Flood Control Project Maintenance Levee Inspections

Fall 2023 Levee Maintenance Deficiency Summary Report

Reclamation District No. 0556 Upper Andrus

Levee Inspection Report By Mile - Fall 2023

Photo 1 of 2 : FA_2023_RD0556_18_43_20231019_00026.jpg

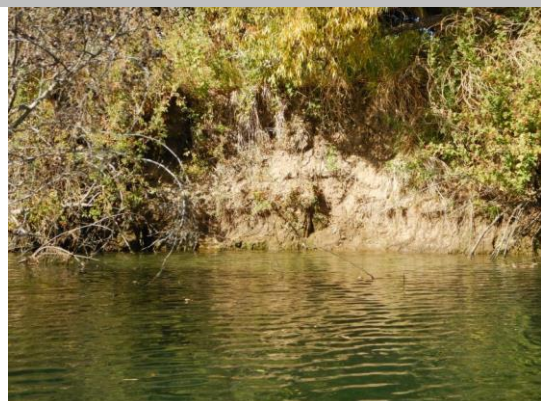
LM Start	0.38	Rating **	M	Issue No.	43
LM End	0.58	Issue Type +	Ma	Location *	WS
Category	Supplemental			GPS Latitude/Longitude	
				Start	End
Item	2018 USACE Erosion Survey			38.234038°	38.231879°
				-121.519817°	-121.522003°
DWR ID	DWR_RD0556_01_s_2022_43				
Comment Code					
Inspector Comment					
2018 Site ID: GEO 11.8 R					
Status: Eroding					
2018 Field Notes: No observed change.					
Site History: 2017 - Tree popout popouts eminent , significant toe erosion and whole bank failure in sections

Photo 1 of 1 : FA_2023_RD0556_18_48_20231019_00032.jpg

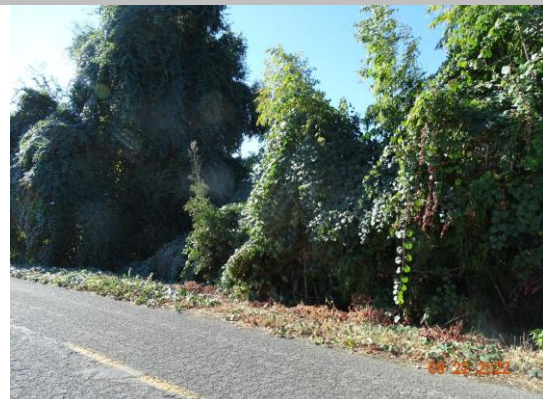
LM Start	2.72	Rating **	U	Issue No.	48
LM End	2.72	Issue Type +	En	Location *	LS
Category	Earthen Levee			GPS Latitude/Longitude	
				Start	End
Item	Vegetation			38.215085°	38.215085°
				-121.540724°	-121.540724°
DWR ID	DWR_RD0556_01_f_2018_48				
Comment Code					
V6 : Landscaping					
Inspector Comment					
Remove wild grapes and bamboo from landside.

Photo 2 of 2 : FA_2023_RD0556_18_36_20231019_00017.jpg

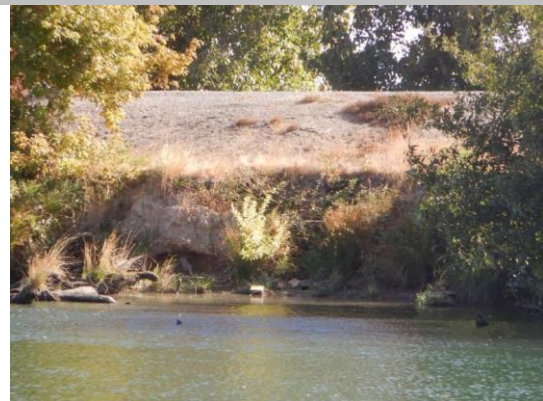
LM Start	3.18	Rating **	M	Issue No.	36
LM End	3.50	Issue Type +	Ma	Location *	WS
Category	Supplemental			GPS Latitude/Longitude	
				Start	End
Item	2018 USACE Erosion Survey			38.210674°	38.206919°
				-121.538854°	-121.541559°
DWR ID	DWR_RD0556_01_s_2022_36				
Comment Code					
Inspector Comment					
2018 Site ID: GEO 9.0 R					
Status: Eroding					
2018 Field Notes: Site extended downstream.					
Site History: 2017 - Toe erosion and failed revetment.

LM Start	3.18	Rating **	M	Issue No.	36 (cont)
LM End	3.50	Issue Type +	Ma	Location *	WS

Photo 3 of 3 : UCIP_FA_2023_76303_113531.jpg

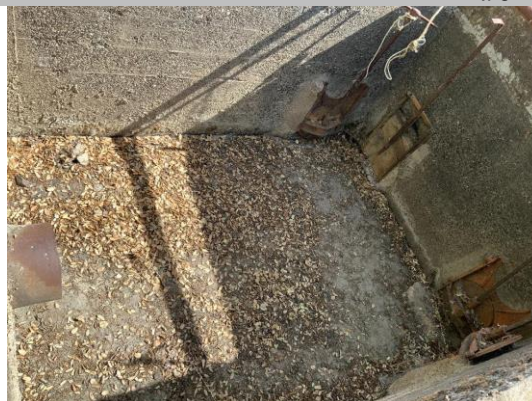
LM Start	3.07	Rating **	U	Issue No.	127 (cont)
LM End	3.07	Issue Type +	En	Location *	
Category	Supplemental		GPS Latitude/Longitude		
			Start	End	
Item	DWR UCIP Field Study		38.226225°	38.226225°	
			-121.555236°	-121.555236°	
DWR ID	20862

LS view: Pipe outlet in box at toe.
